**PLANNING COMMISSION
THURSDAY, AUGUST 11, 2022 6:00 PM**

RE: COPC: Carlyle Drive and East Main Street

**COPC Reynoldsburg
Medical Office Building**
8077 East Main St.
Reynoldsburg, Ohio 43068
FOR
Central Ohio Primary Care

CITY OF REYNOLDSBURG, FRANKLIN COUNTY, OHIO
FINAL DEVELOPMENT PLAN
FOR
COPC REYNOLDSBERG
E MAIN ST
TITLE SHEET

CITY OF REYNOLDSBURG, FRANKLIN COUNTY, OHIO
FINAL DEVELOPMENT PLAN
FOR
COPC REYNOLDSBERG
E MAIN ST
OVERALL SITE PLAN

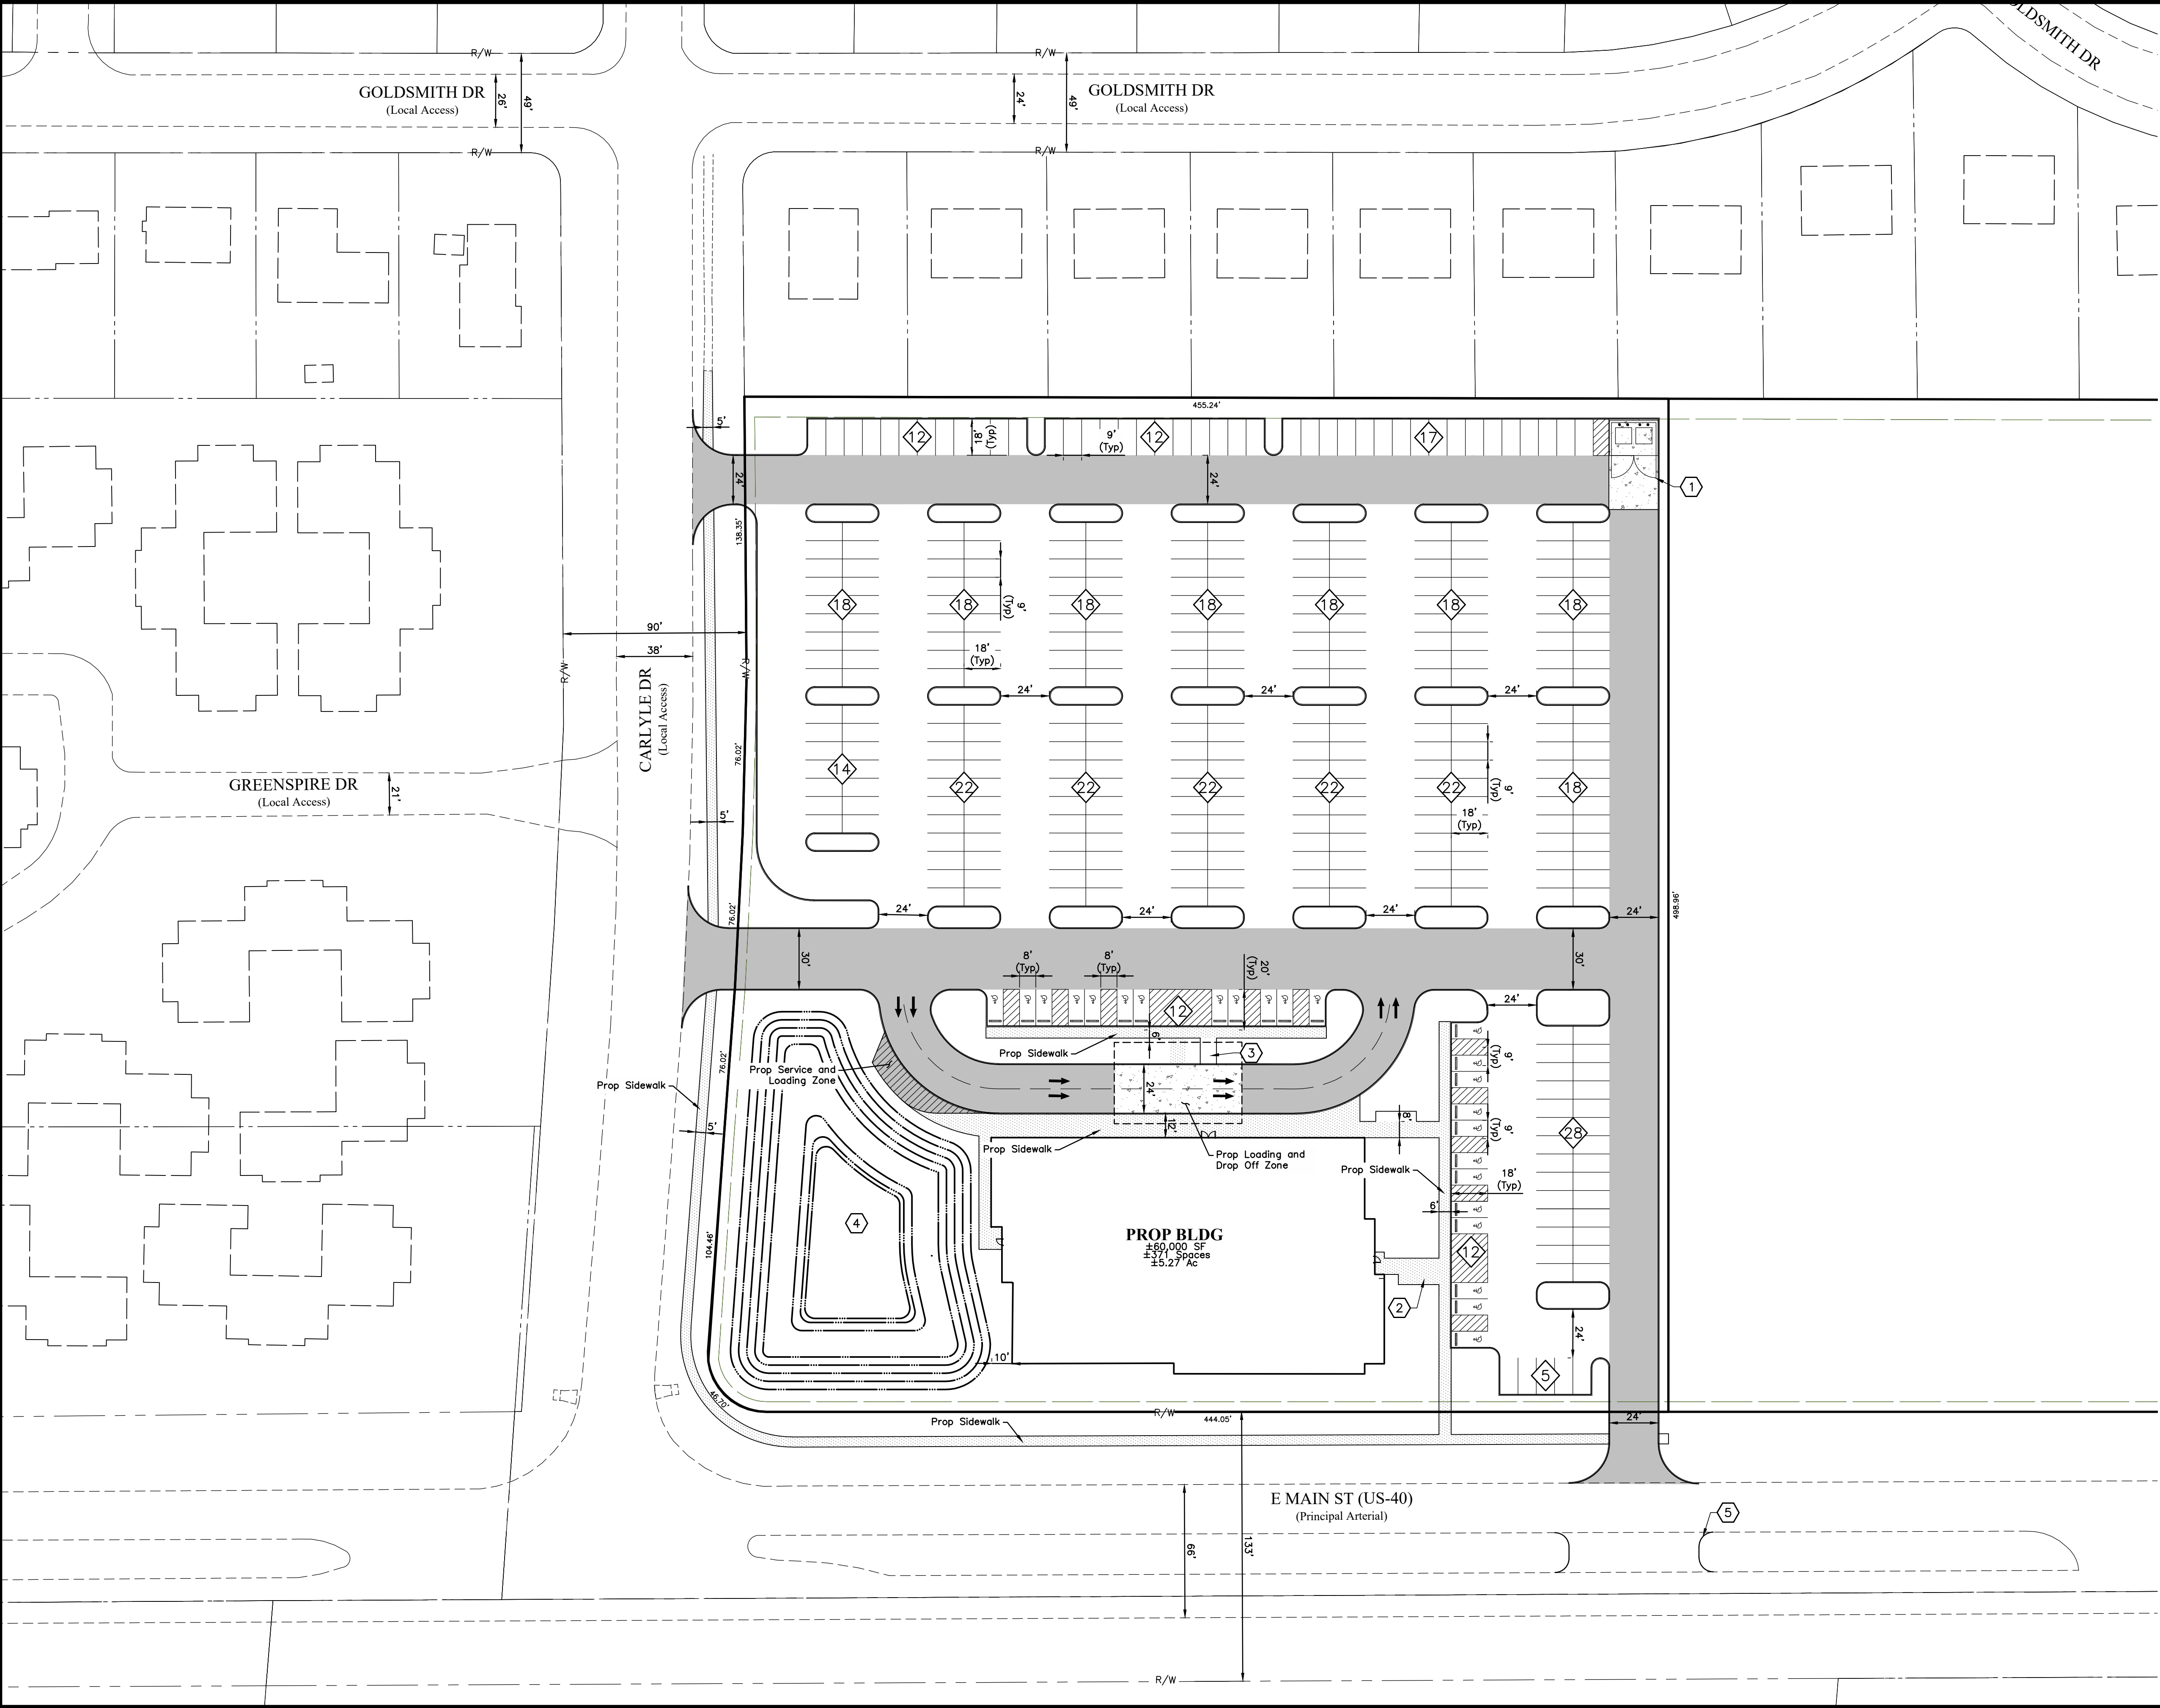
- a. As a follow-up to our prior review of the dry detention facility we discussed with the Engineer having the safety shelves and setbacks to various storm events. It appears as if the Engineer has provided a dry pond design that we find acceptable from a functionality standpoint. The 'dry river' bed technic proposed has been successfully implemented throughout central, Ohio providing the owner of the building maintains this stormwater facility appropriately. We will discuss during final engineering at the PGU stage, but a maintenance manual should be provided for this facility to ensure it does not become an aesthetic issue for the community in the future.

- c. We would like to see what the relationship is for the overhead utilities along Main Street and the proposed building. Typically, 10' OSHA separation is required between building construction and overhead utilities. If the applicant can demonstrate there are no conflicts, we have no further comment on this issue.

- d. The pond and any sidewalks should also be coordinated with the locations of utility poles, telecommunication pedestals, etc. to ensure there are no conflicts. The site plan should be adjusted accordingly. If the applicant can demonstrate there are no conflicts, we have no further comment on this issue.

CITY OF REYNOLDSBURG, FRANKLIN COUNTY, OHIO
FINAL DEVELOPMENT PLAN
FOR
COPC REYNOLDSBERG
E MAIN ST
OVERALL UTILITY PLAN

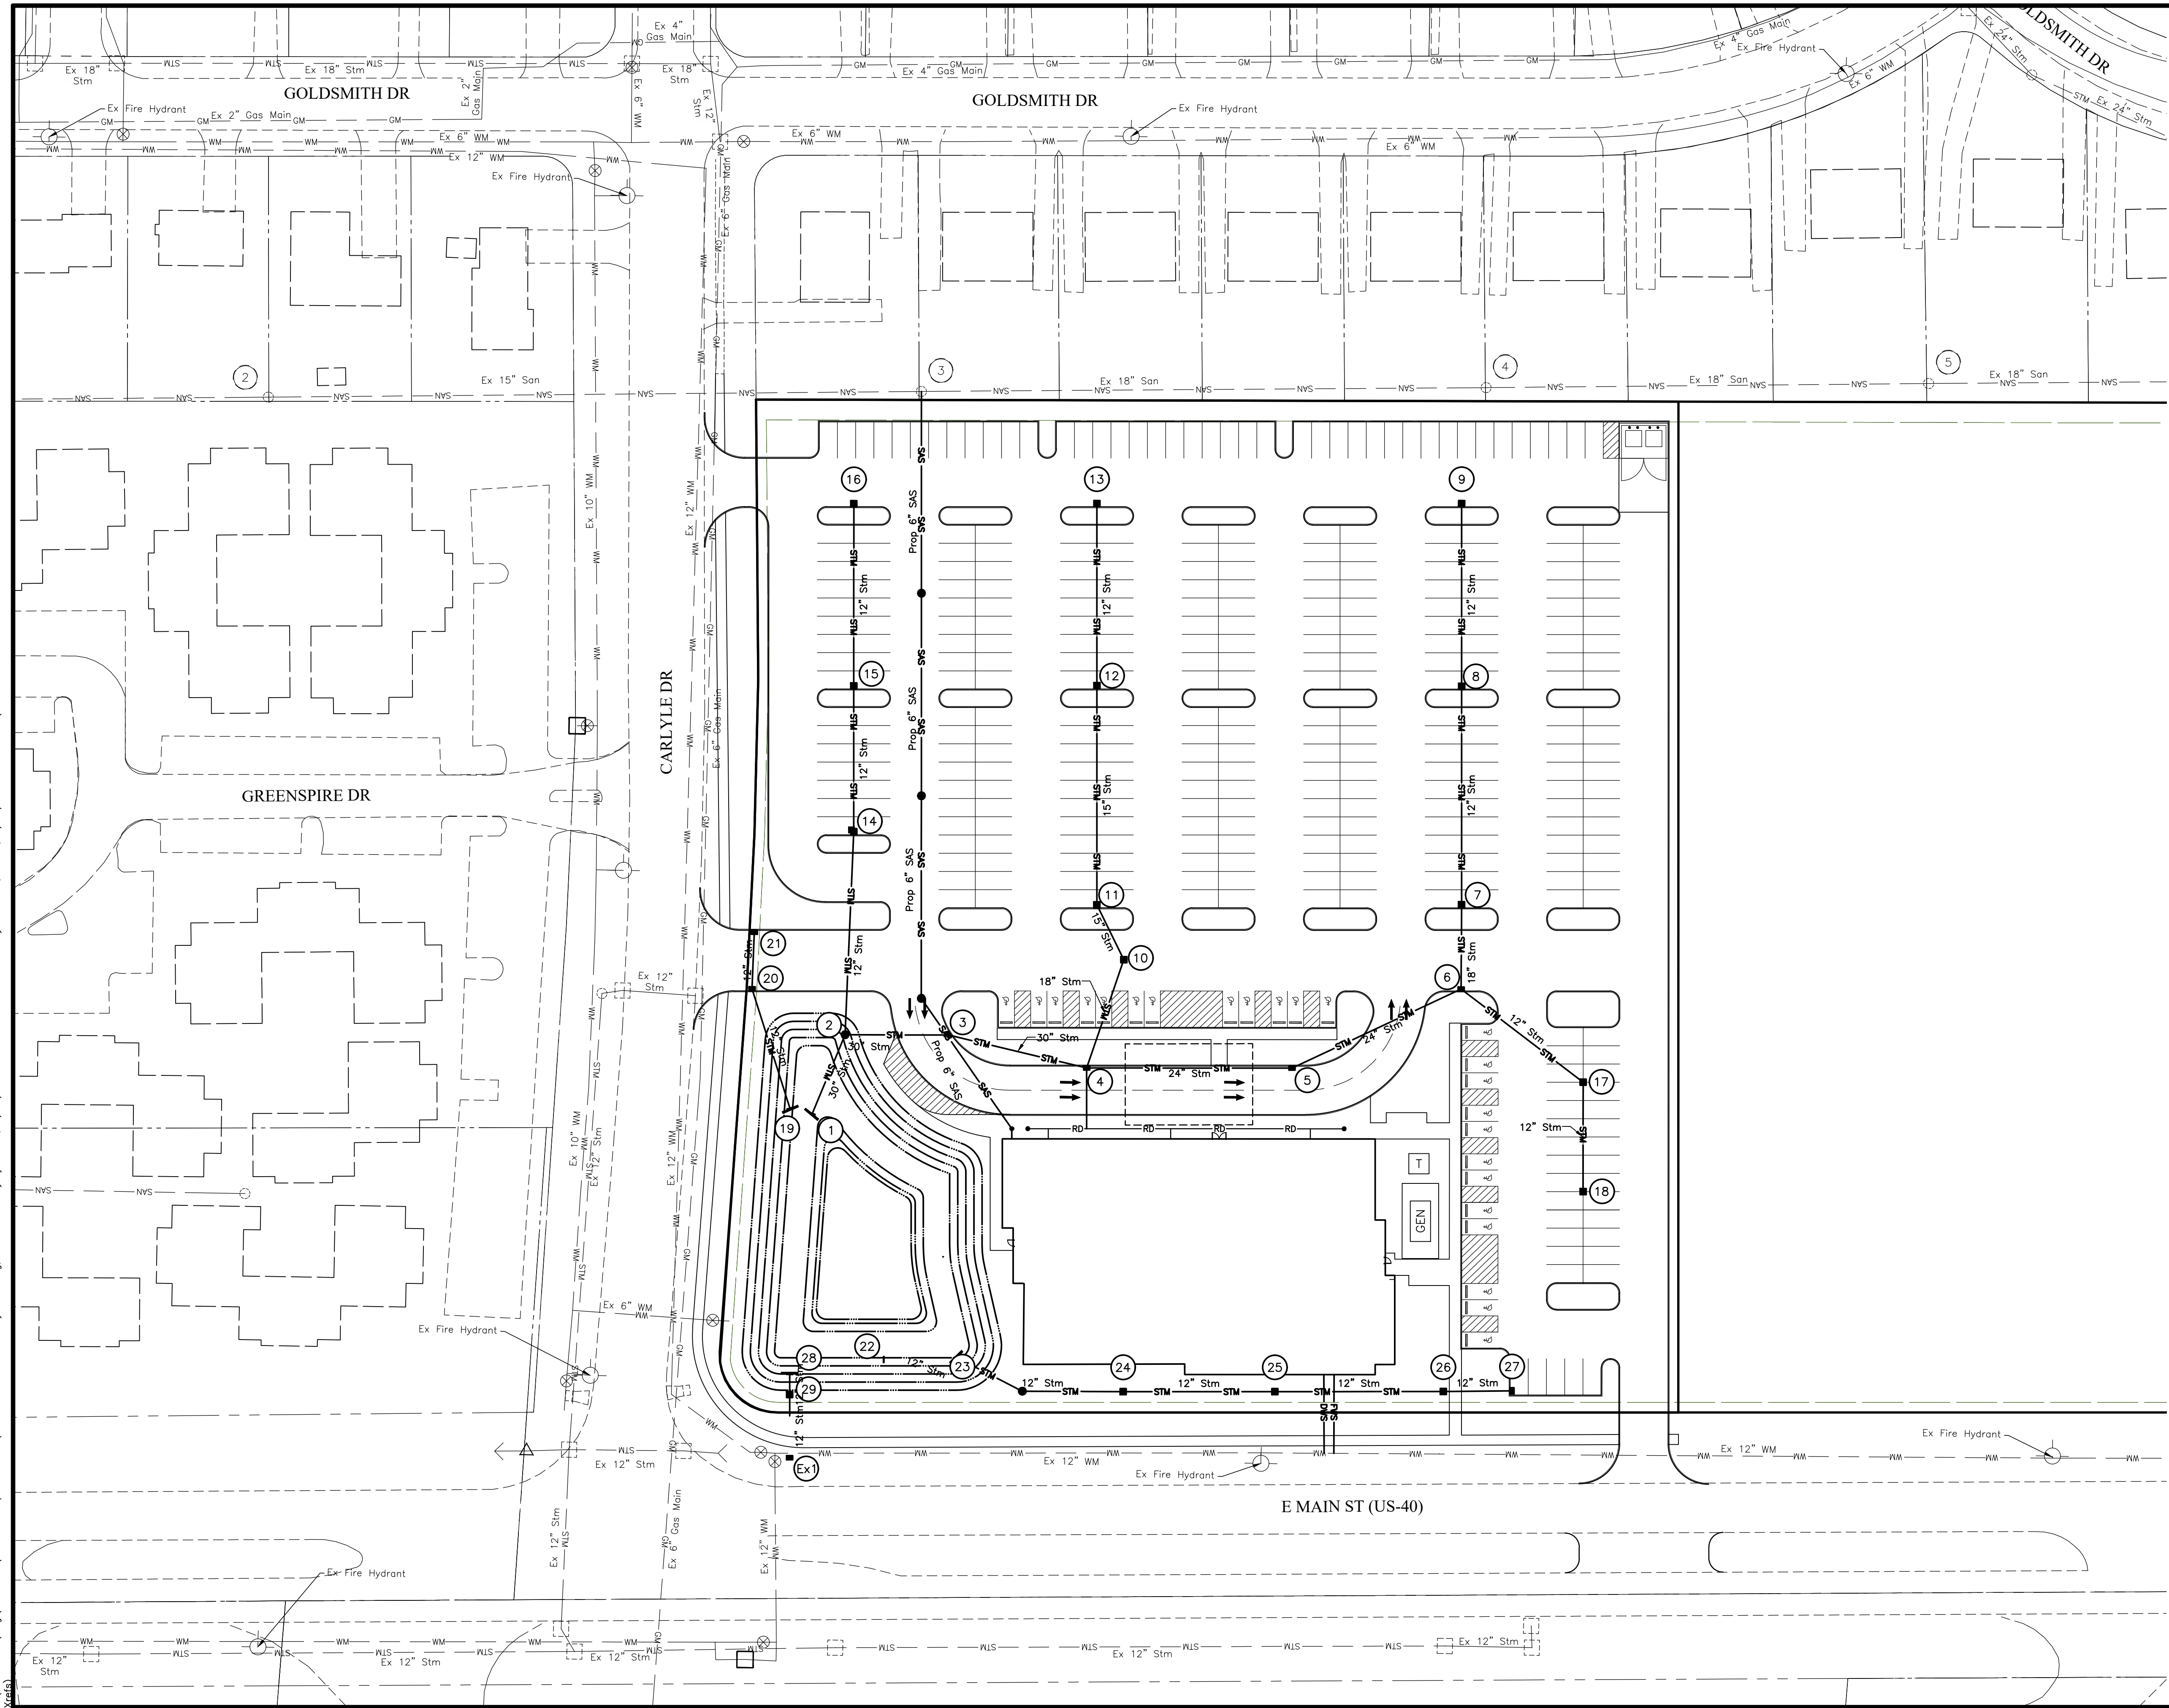
- b. We will discuss in more detail during the PGU process, but the sanitary shown appears to be a lateral with cleanouts. This sewer lateral will need to tie into the main at a wye and not at a manhole."

- e. There appears to be conflicts between the site lights and storm sewers shown on each plan. It is recommended that the site lighting be coordinated with the utility plan. The lighting photometrics should be updated if the site light locations change. Approval of the site plan is recommended with the condition that the lighting plan be updated to reflect the current plan.
